7ABC BAYHAM STREET CAMDEN LIFESTYLE

SECTION 73 PROPOSED SCHEME AMENDMENTS
PLANNING APPLICATION
NOVEMBER 2020

This document has been prepared to present the amendments to the consented scheme (Ref: 2018/3647/P) which are predominantly internal and designed to suit the hotel brand.

SECOND FLOOR

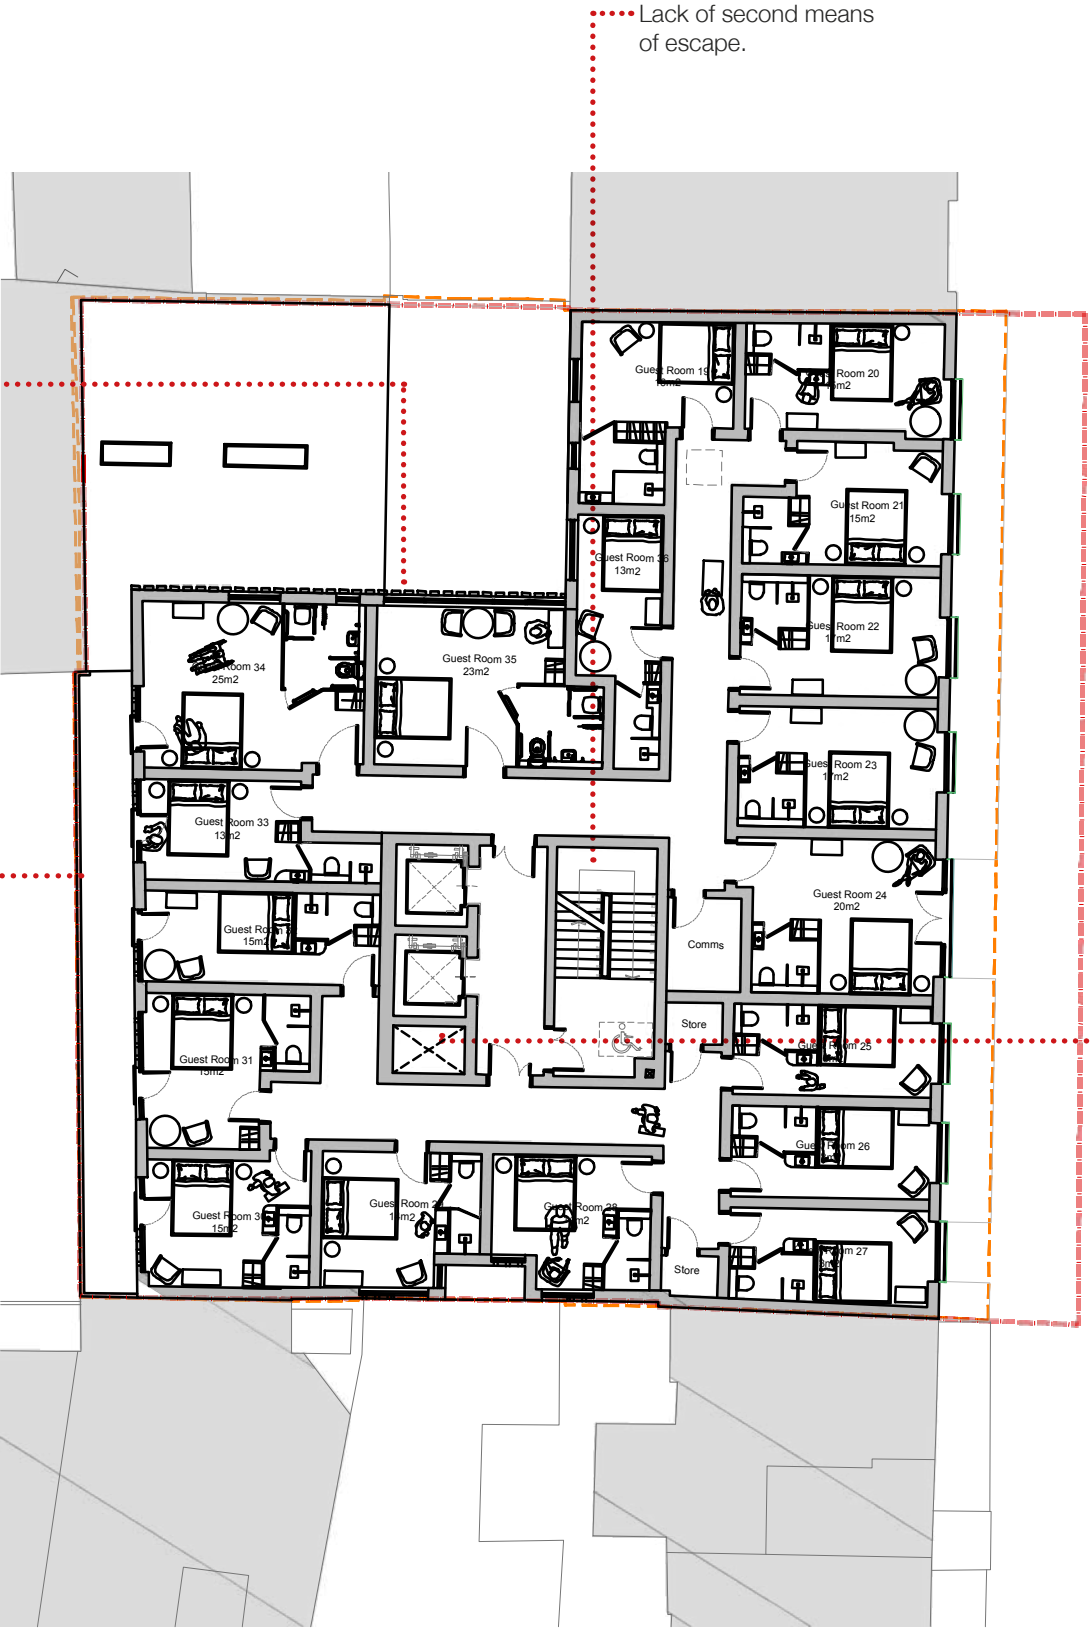
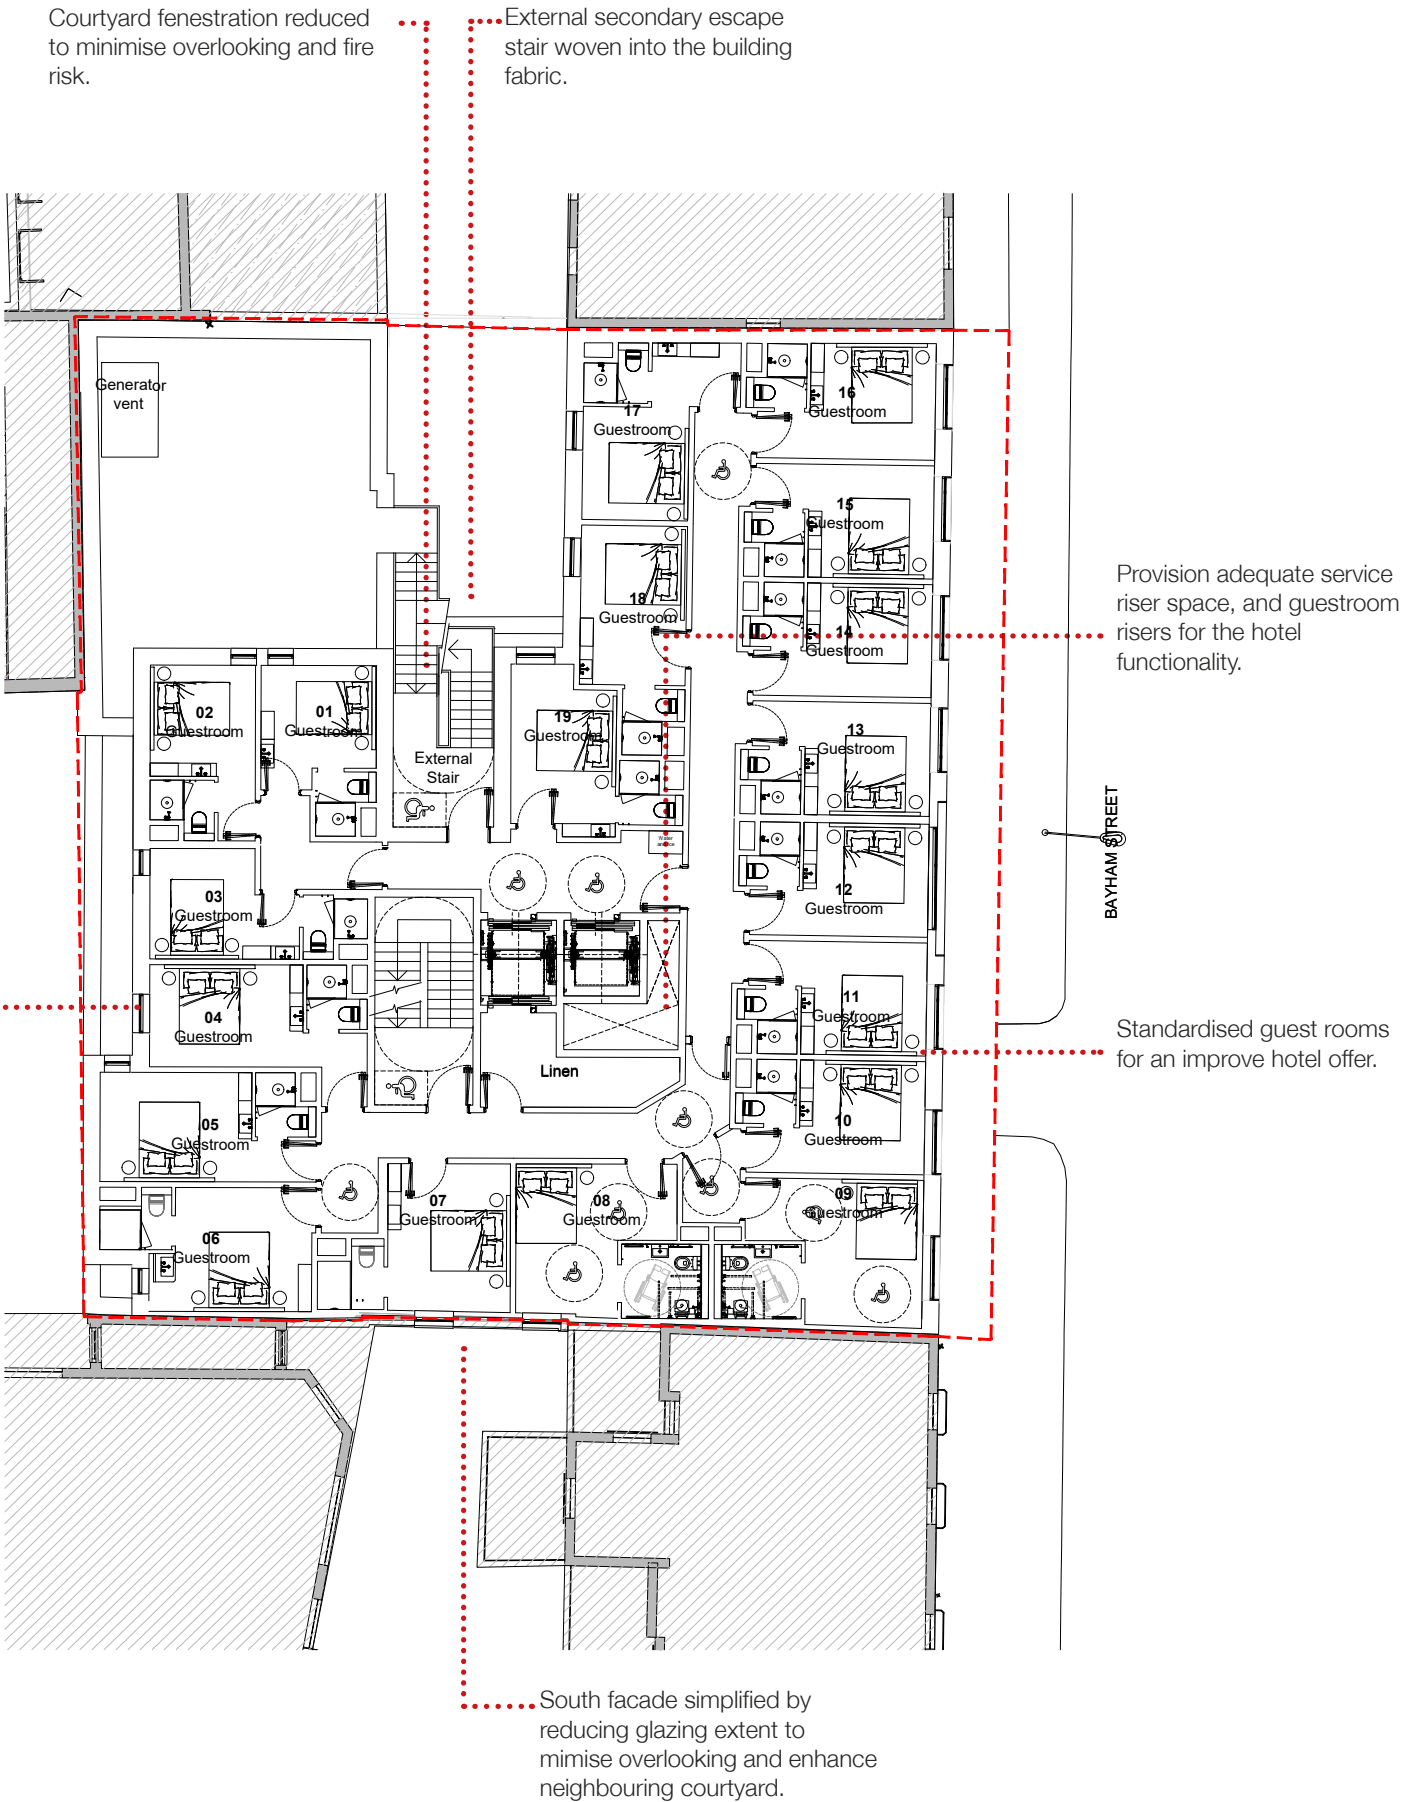
Excessive glazing into courtyard,
impacting on overlooking issues
and maintenance.

Retained wall compromises 2.5
levels of guestroom outlook.
Lightwell is too narrow for
intended use and creates a
maintenance issue.

Lack of second means
of escape.

Lack of services riser space
in core and also within
guestroom spaces.

- Guestroom configurations revised to improve the general circulation with the scheme.
- Guestroom layouts standardised to align with brand requirements.
- Linen stores introduced to each level with direct lift access.
- Risers allowed for to comply with MEP requirements.
- The consented scheme had insufficient space allowance for MEP services distribution. One Riser was provided to distribute the MEP services vertically through the building, although BS define segregation between MEP services. The proposed scheme includes the provision for a dedicated Vertical risers to distribute MEP equipment between the roof and basement areas.
